UI Bulletin #159

Subject:	Cap-less Fuel Cover
Models Years Affected:	2017 - 2019
Models Affected:	Chevrolet Silverado (old body style) GMC Sierra (old body style) With Cap-less Fuel Fill and Gasoline Engines
Origination Date:	September 4, 2019
Revision Date:	N/A

Figure 1

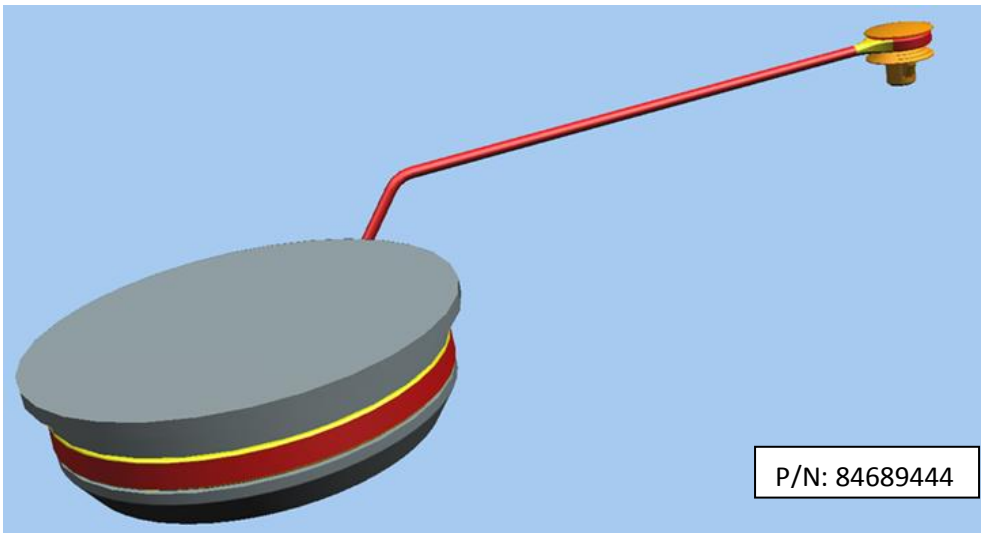
Some customer/vehicle operators may express a concern that dirt, dust and other contaminates have a potential of entering the fuel filler/tank due to contaminants making their way past the seals on the cap less unit. This issue may occur on vehicles that predominately drive on unsealed or dirt roads. This issue occurs because the fill pocket is unsealed near the hinge, and the fill pocket door is also unsealed.

Adding a tethered cap that covers the cap-less unit preventing contaminates from settling on the outer sealing door of the cap less unit. Refer to Additional Information for an illustration (Figure 1) and the part number of the tethered cap.
